Proposed ‘House (not elsewhere specified)’ Development and Proposed Minor Relaxation of Maximum Plot Ratio Restriction in “Residential (Group D)” Zone at Lots Nos. 407 S.A ss.2 S.A and 408 S.B ss.1 RP in D.D. 94, Hang Tau Tai Po, Kwu Tung South, New Territories (Application No.: A/NE-KTS/538) – Further Information

Proposed ‘House (not elsewhere specified)’ Development and Proposed Minor Relaxation of Maximum Plot Ratio Restriction in “Residential (Group D)” Zone at Lots Nos. 407 S.A ss.2 S.A and 408 S.B ss.1 RP in D.D. 94, Hang Tau Tai Po, Kwu Tung South, New Territories (S.16 Planning Application TPB Ref: A/NE-KTS/538)

Figure 5a - Master Layout Plan

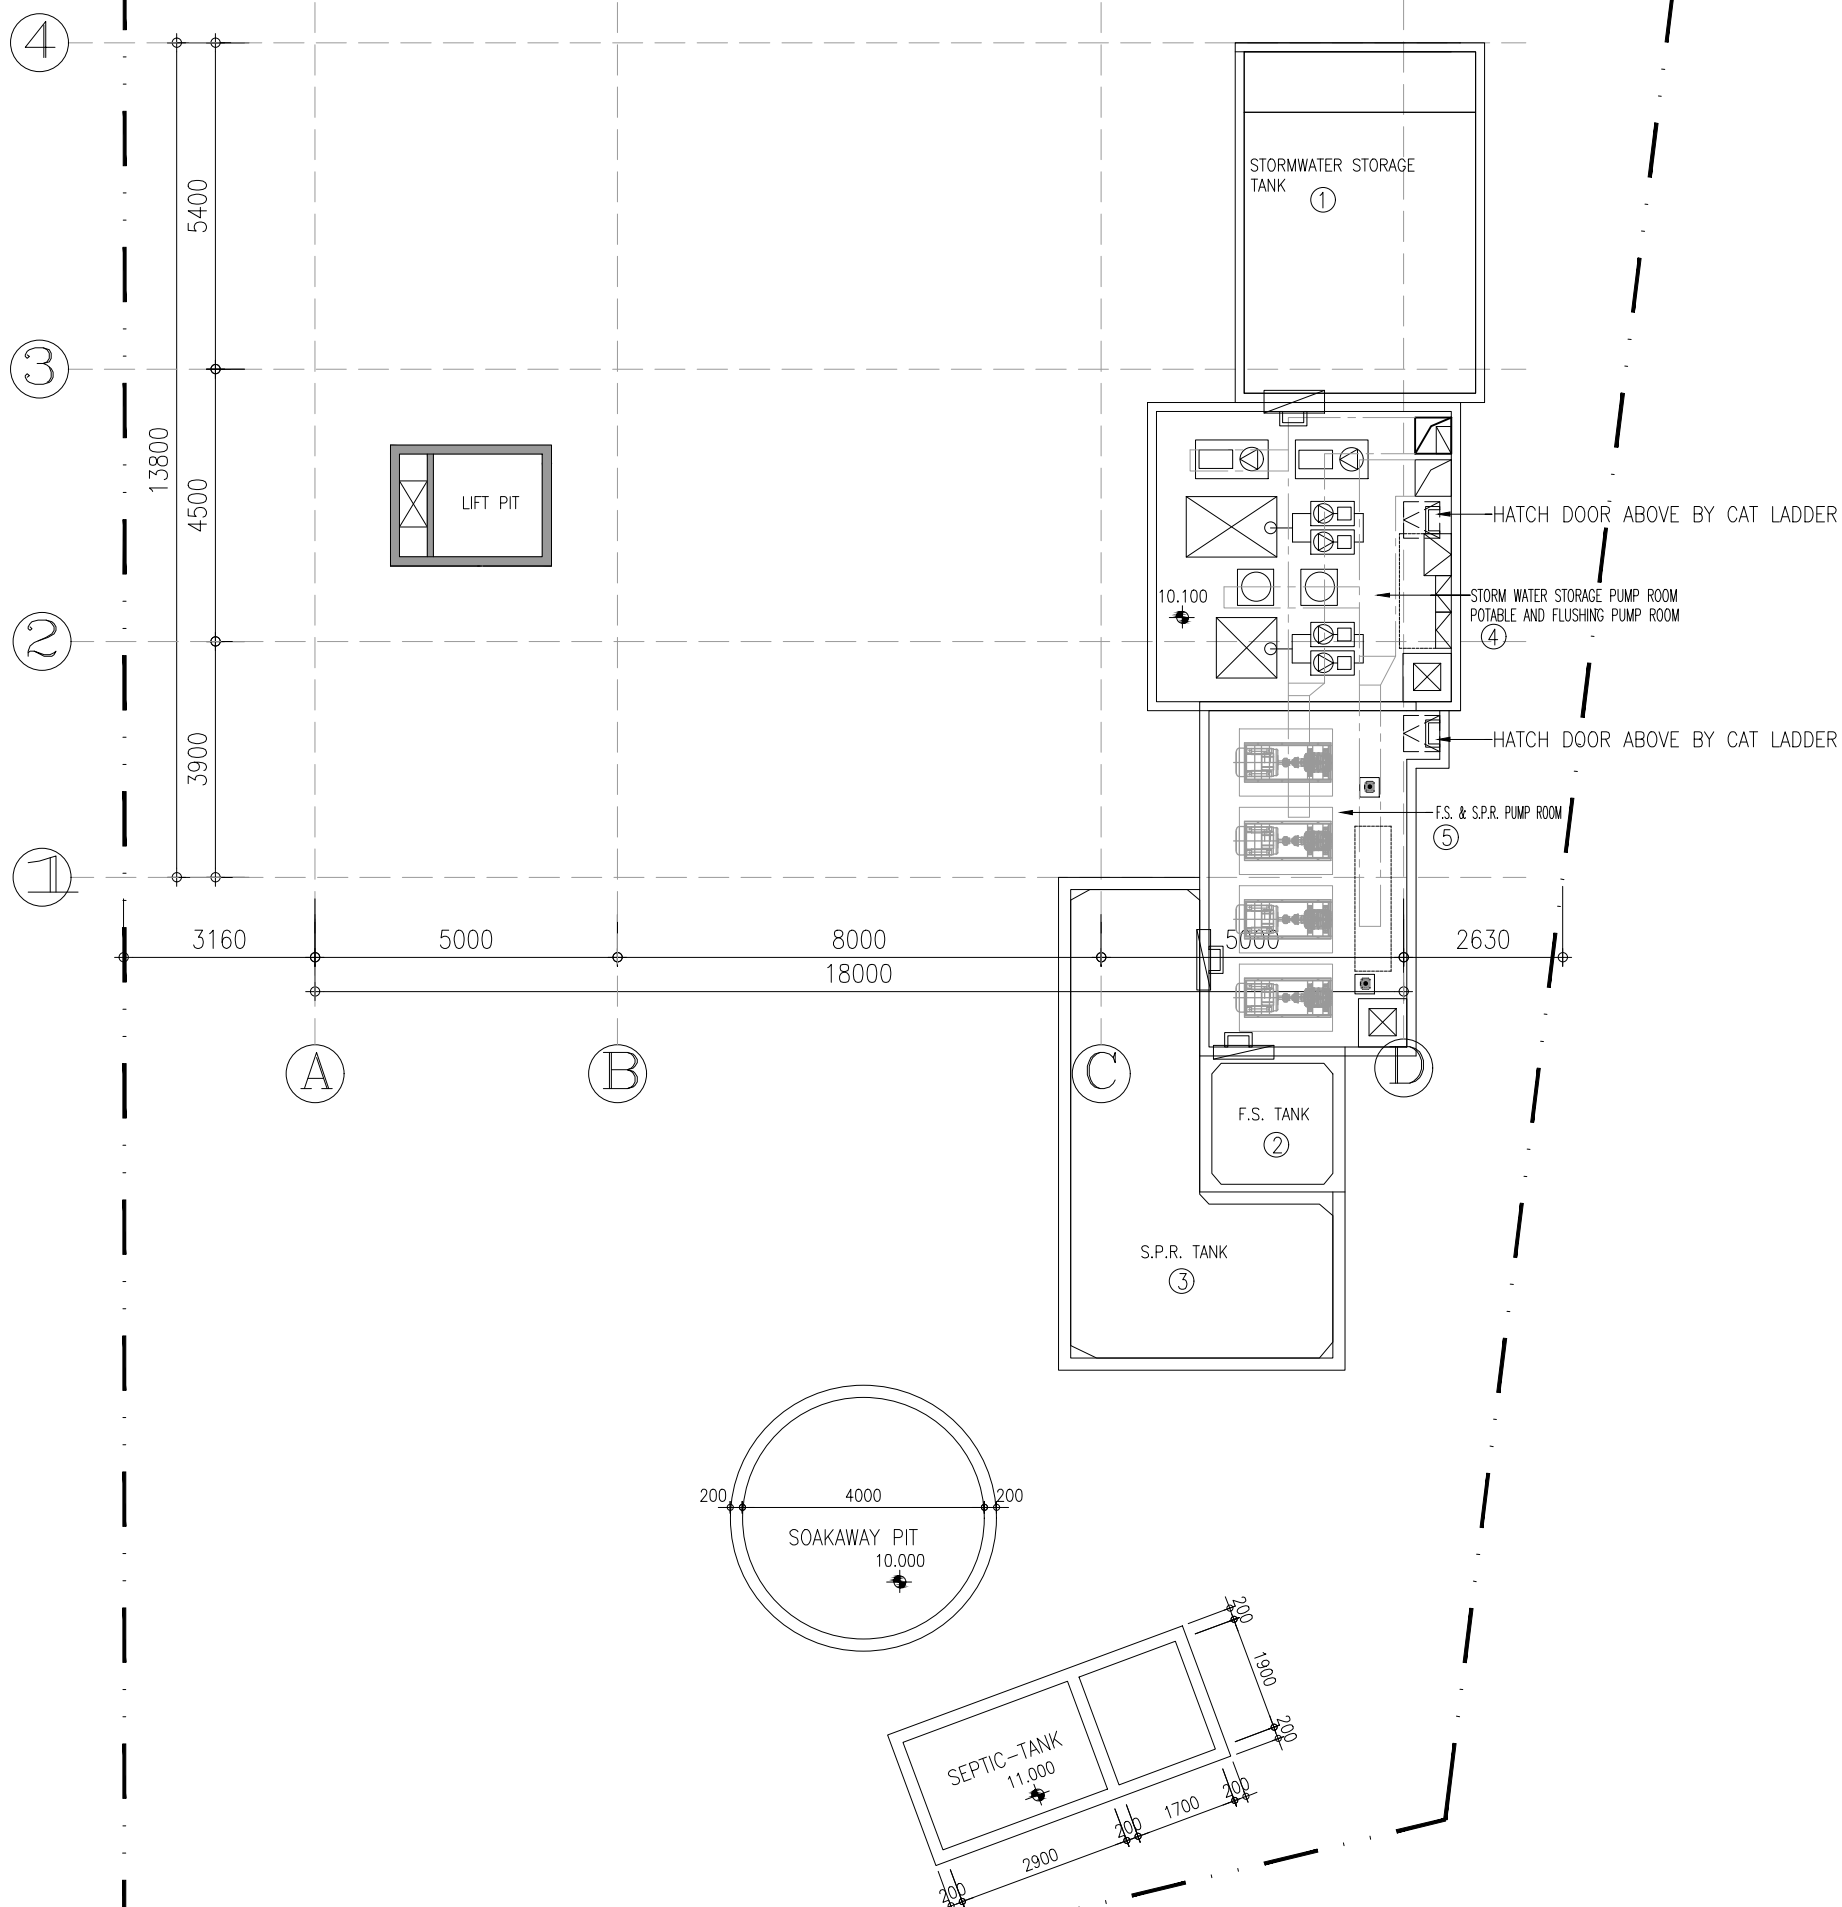
2.	<p>According to paragraph 4.4 of the Planning Statement, a boundary set back of around 0.7m to 1.9m from the existing local access road along the western boundary of the Application Site is proposed to offer an opportunity to widen this section of local access road.</p> <p>In the event that the proposed boundary would be set back from the Application Site, the Applicant is required to clarify the management and maintenance issue of the concerned setback area.</p>	<p>Noted.</p> <p>The Applicant will undertake the responsibility for constructing, managing and maintaining the setback area within the Subject Site to the satisfaction of relevant government departments, until the government demands to take back the long-term management and maintenance of such setback area, should the current</p>

Departmental Comments		Applicant's Responses
	<p>Furthermore, by referring to Figure 5 – Master Layout Plan of the Planning Statement, the Applicant should clarify the extent of the adjoining private lots affected by the proposed road widening works. For any proposed road widening works that would affect third party private lots, the Applicant should demonstrate consent from the concerned private lot owners for the right of access, construction works, etc. have been obtained.</p>	<p>application be approved.</p> <p>No third party private lot will be affected under the current application.</p>
	<u>Septic Tank</u>

3.	<p>Lastly, while the said setback area would not form part of the regrant lot of the land exchange application (if submitted), the Applicant is requested to justify why the proposed septic tank which solely serves the subject development (by referring to Figure 5 – Master Layout Plan and Figure 7 – Ground Floor Plan of the Planning Statement) would need to partially fall beyond the regrant lot boundary.</p>	<p>The location of the proposed septic tank has been revised accordingly (see Figure 5a and Figure 7a).</p>

- a. the total domestic GFA should be read as about 488.64m² (see **Annexes A and B**);
- b. the areas for road widening and for self-circulation purposes are about 26 m² and about 28 m² respectively (see **Figure 5a**). The overall setback area is about 54m² and the outside amenity planter area is about 16m² in extent; and
- c. A pedestrian route to the minibus station is attached in **Annex C** for easy reference.

OTHER SET BACK AREA 28m²
 SET BACK ROAD AREA 26m²

Figure 6a - Basement Floor Plan

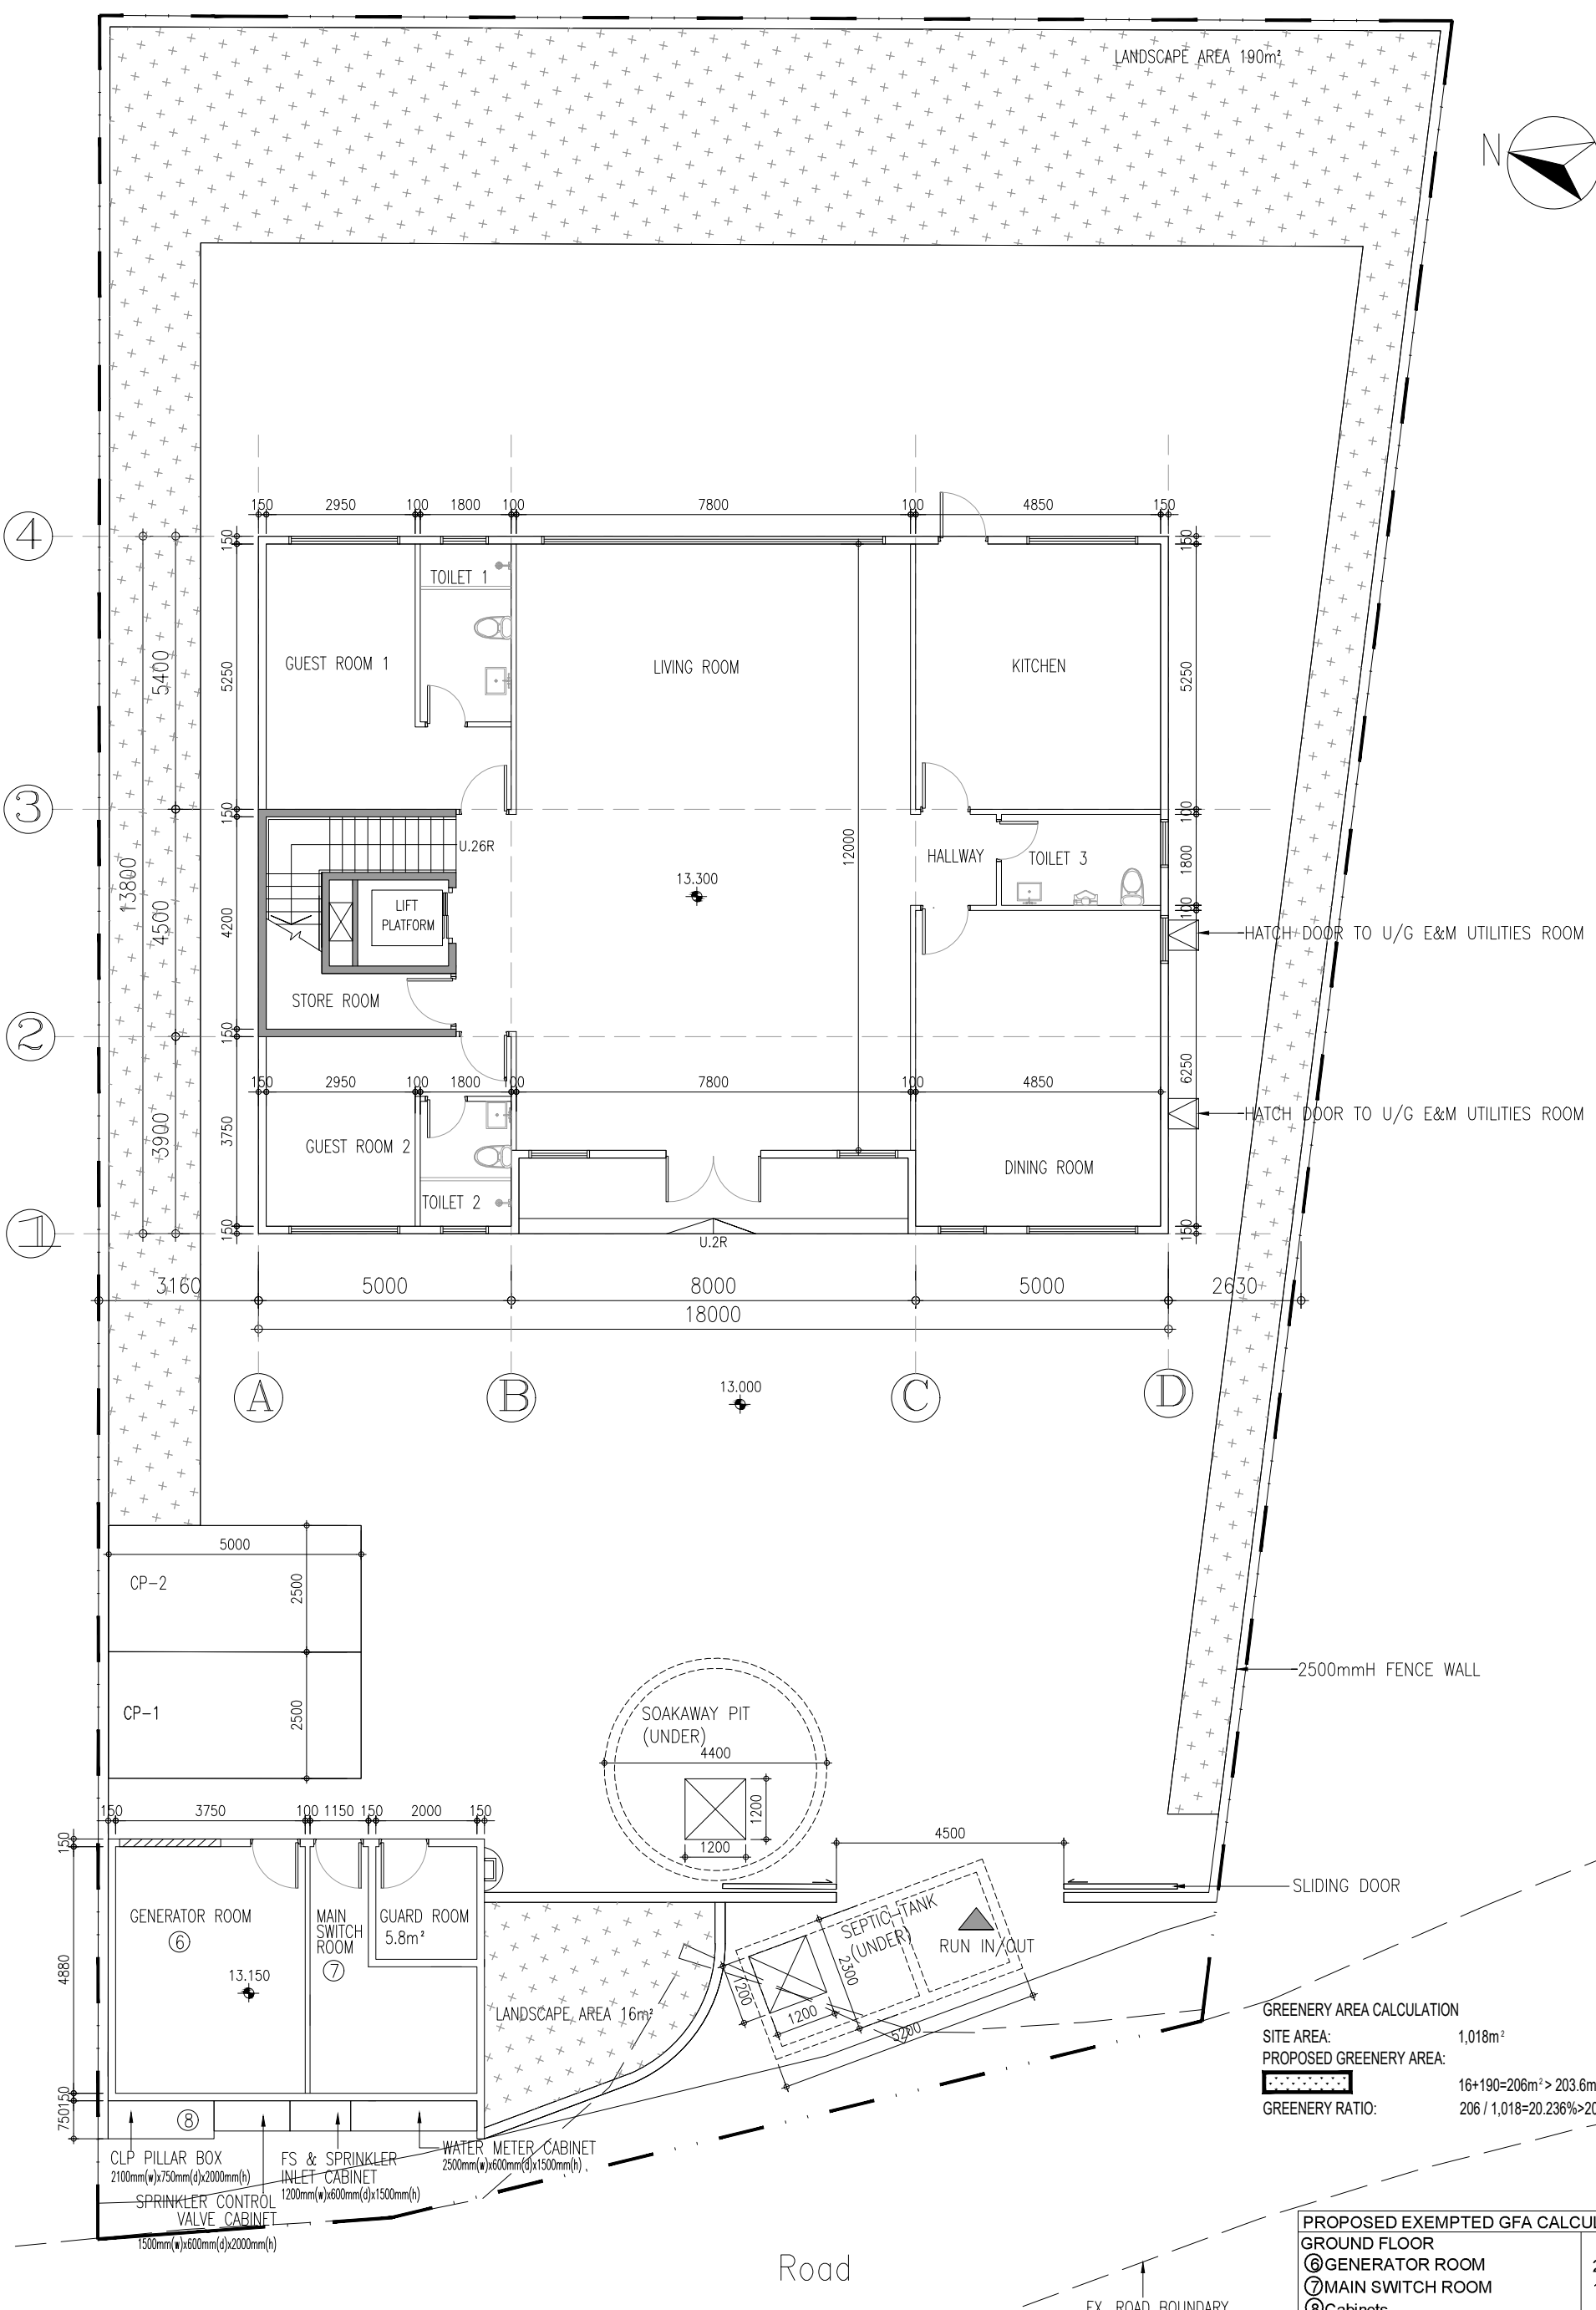
Departmental Comments		Applicant's Responses
C. Comments from the Chief Buildings Surveyor/New Territories West, Buildings Department received on 6 June 2024		
	<u>Accountability of Basement Floor</u>	
1.	Based on the information provided with consideration of the size, location and use, the underground E&M facilities and water tanks with access through cat ladder directly from internal part of the proposed house may be considered as a basement under the Buildings Ordinance (BO).	Please note that the proposed underground M&E utilities and associated plant rooms will only be connected by hatched doors located outside the proposed building. These underground essential ancillary facilities shall not be treated as a basement floor. Figures 6b, 7a and 11a in Annex A are being revised to replace their original ones.

Figure 7a - Ground Floor Plan

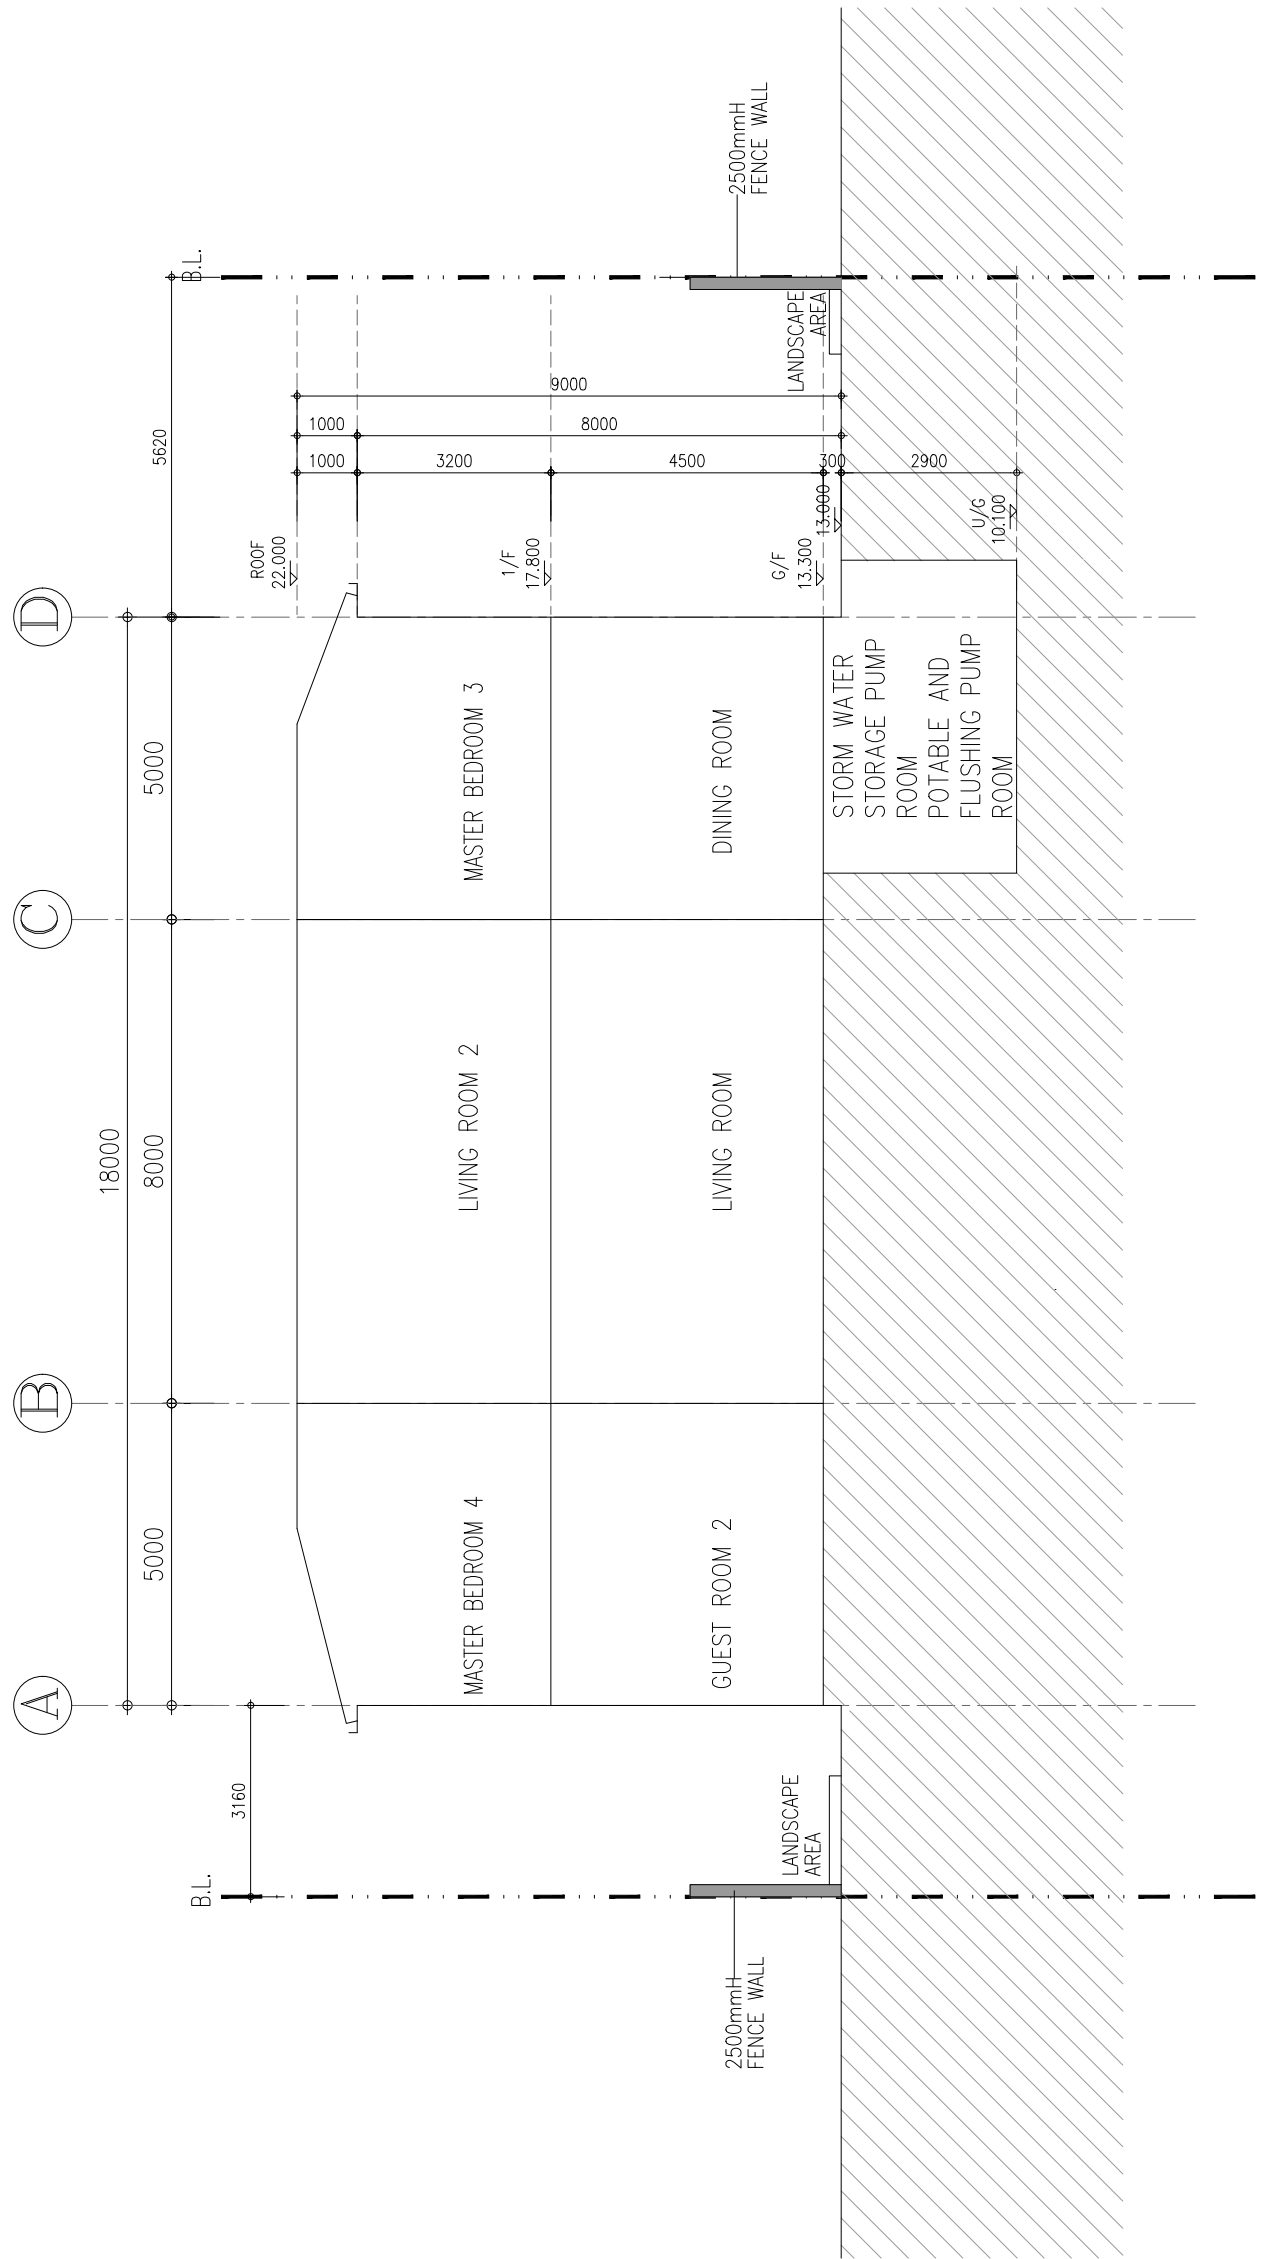
1.	<p>It is noted from the application form that the “number of units” is “1”. The Applicant should note that guard room which is taken as caretakers’ / watchmen’s office (as shown on Figure 7 – Ground Floor Plan of the Planning Statement in this case) would in general not be exempted from gross floor area calculation in case the concerned private lot is developed as a single house development.</p> <p>Please clarify if the proposed GFA has taken into account the GFA required for the Guard Room.</p>	<p>Noted. The GFA of the Guard Room is now being included in the proposed GFA. Figure 5a and Figure 7a in Annex A, and para. 4.1 and Table 2 in the Planning Statement as attached in Annex B have been updated accordingly.</p>
	<u>Widening of local access road</u>
